TECHNICAL SERVICE BULLETIN

Poor A/C Performance - Evaporator Housing Can Now Be Serviced Separately From The Climate Control Housing Assembly/Add Cabin Air Filter

19-2388
19 December
2019

Ford 2015-2019 Transit

Figure 1

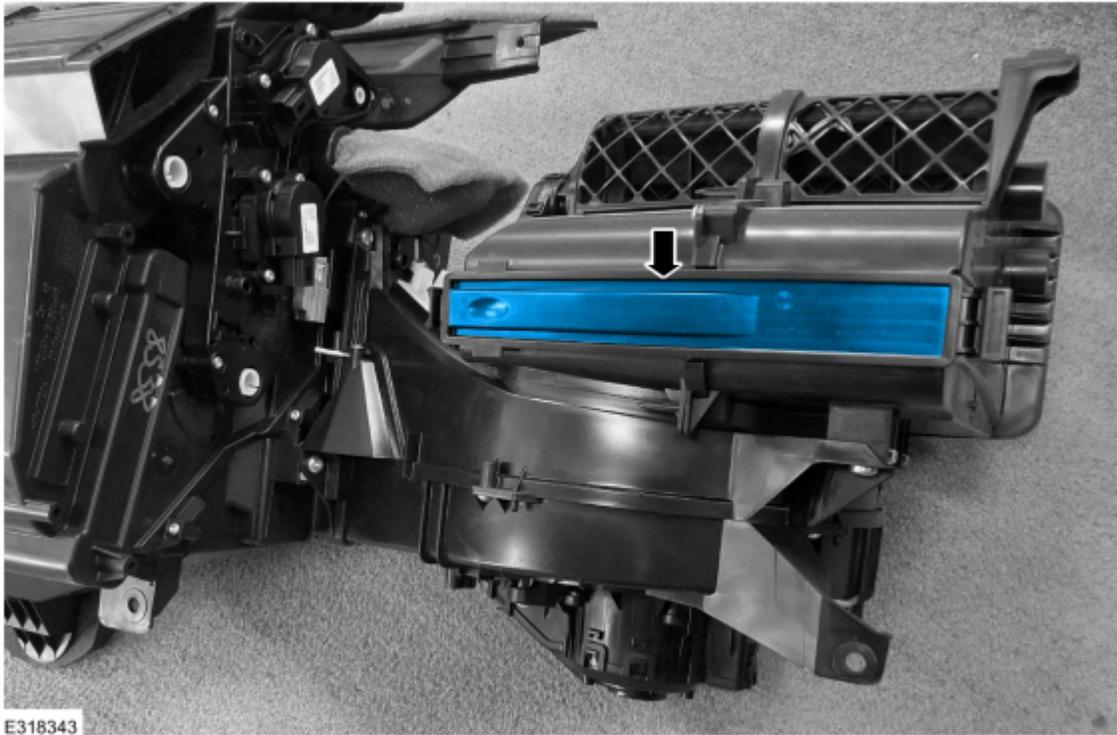
1. Inspect the A/C system. Does the system show signs of leaks in components other than the evaporator?
 - (1). Yes – this article does not apply. Refer to Workshop Manual (WSM), Section 412-00.
 - (2). No – proceed to Step 2.
2. Remove the climate control housing. Refer to WSM, Section 412-00.
3. Remove the retaining clip from the bottom of the housing. (Figure 1 Callout 1)

4. Remove the 3 retaining screws and separate the blower motor case from the evaporator housing. (Figure 1 Callout 2)
5. Attach the blower motor case to the new evaporator housing and install the 3 retaining screws. Tighten the 3 retaining screws to 3.7 Nm +/- 0.6 (32.75 lb-in +/- 5.31).
6. Install the remaining clip.
7. Install the cabin air filter in case above blower motor.(Figure 2)
